BOARD OF ZONING APPEALS STAFF REPORT

Agenda Item: BZA Docket No. 21-009

Summary: Legacy Sign Group on behalf of MARVL LLC requesting approval of multiple

SECTION 26-6.701.B.5.t for a monument sign at 1750 45th Street.

Figure 1: Original sign submitted for variances

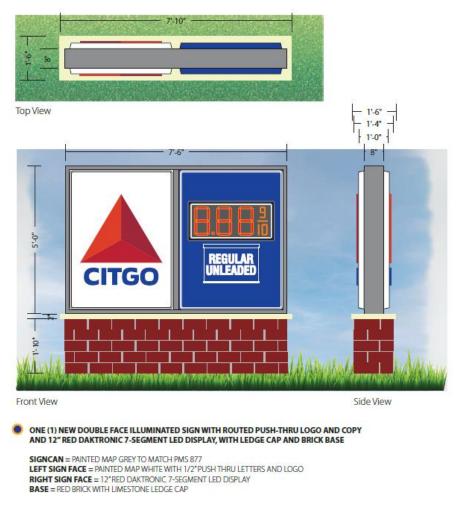
The original variances being requested were as follows:

Code Section	Standard	Permitted	Proposed
TABLE 26-6.701.B	MONUMENT SIGN SPECIFIC STANDARDS - AREA	18 square feet maximum	37.5 square feet

TABLE 26-6.701.B	MONUMENT SIGN SPECIFIC STANDARDS – HEIGHT	6 feet maximum	7 feet
TABLE 26-6.701.B	MONUMENT SIGN SPECIFIC STANDARDS- Additional Standards a.	Shall be located within the 1st Lot Layer and shall be set back at least 10 feet from the public right-of way;	5-foot setback from the public right-of-way
SECTION 26- 6.701.B.5.t	General Sign Provisions.	Except as may be expressly permitted in this Article, Neon Signs, Cabinet Signs, and Projection Signs are not permitted.	Cabinet-style monument sign

Figure 2 **Revised** sign submitted for variances

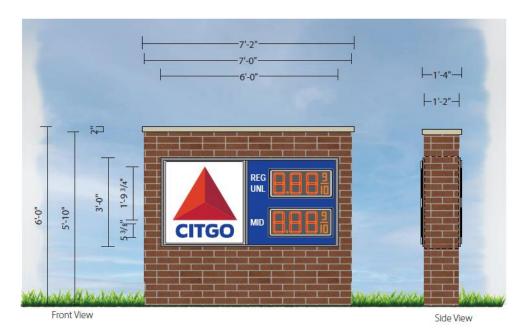
After the application was tabled by the Board of Zoning Appeals at their August 10, 2021 public hearing, the applicants revised the sign, reducing the height, decreasing the overall sign area, and increasing the amount of brick.

The revision to the plans leaves the following variances:

Code Section	Standard	Permitted	Proposed
TABLE 26-6.701.B	MONUMENT SIGN SPECIFIC STANDARDS- Additional Standards a.	Shall be located within the 1st Lot Layer and shall be set back at least 10 feet from the public right-of way;	5-foot setback from the public right-of-way
SECTION 26- 6.701.B.5.t	General Sign Provisions.	Except as may be expressly permitted in this Article, Neon Signs, Cabinet Signs, and Projection Signs are not permitted.	Cabinet-style monument sign
TABLE 26-6.701.B	MONUMENT SIGN SPECIFIC STANDARDS- Additional Standards a.	Sign face made of authentic brick, stone, or solid metal or wood, with lettering, logo or branding made of solid metal or channel lettering;	Plastic faced cabinet
TABLE 26-6.701.B	MONUMENT SIGN SPECIFIC STANDARDS- Additional Standards	Letters and symbols no greater than 12 inches in height	1'-9 3/4" Citgo logo
